Planning Assessment Officer Report

PA2604170 – 674 High
Street, Prahran

Recommendation: Grant planning permit PA2604170

Figure 7 - Extract of a typical section of the building showing compliance of the proposal against clause 55.02-3 where adjacent to the GRZ10 and NRZ3.

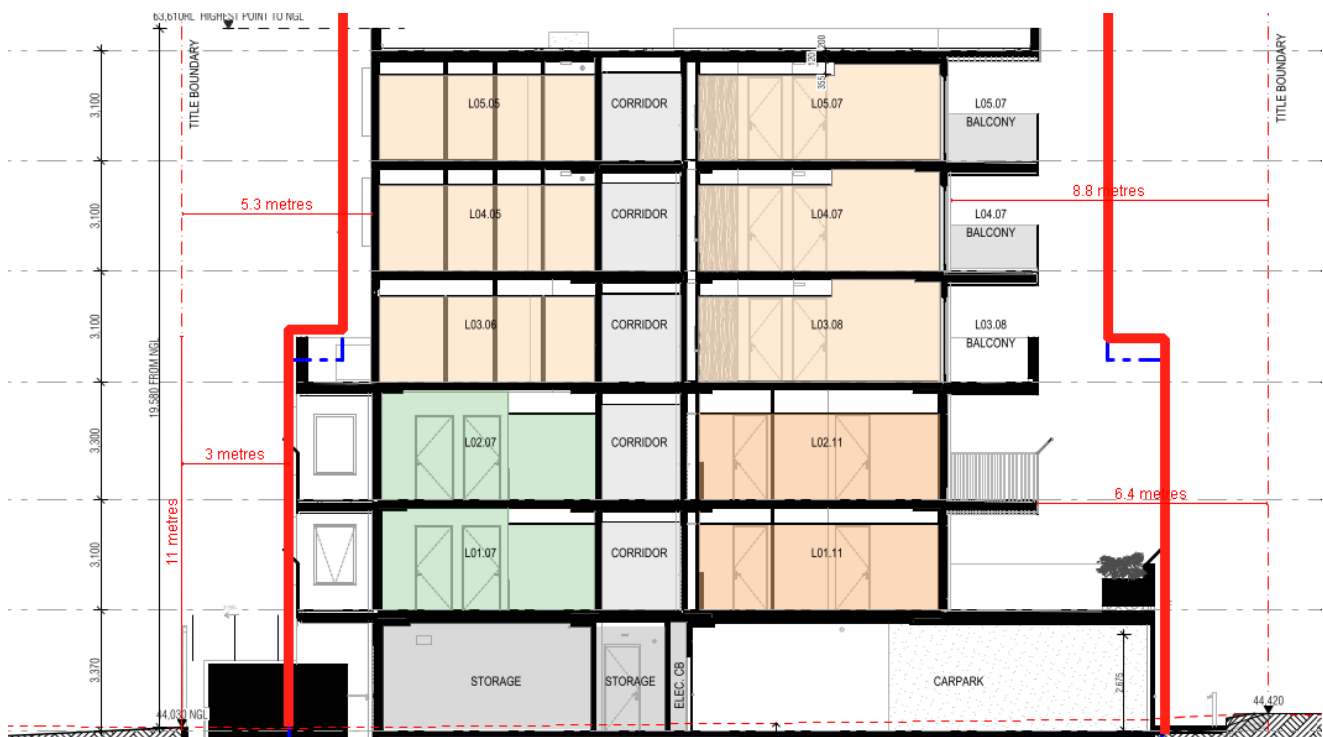
- The development avoids a boundary-to-boundary outcome and the overall building is designed to be set back from the side boundaries to largely comply with the requirements of clause 55.02-3 (Side and rear setback), including that part of the site where it is adjacent to land zoned within the GRZ10 and NRZ3. Refer to Figure 7.
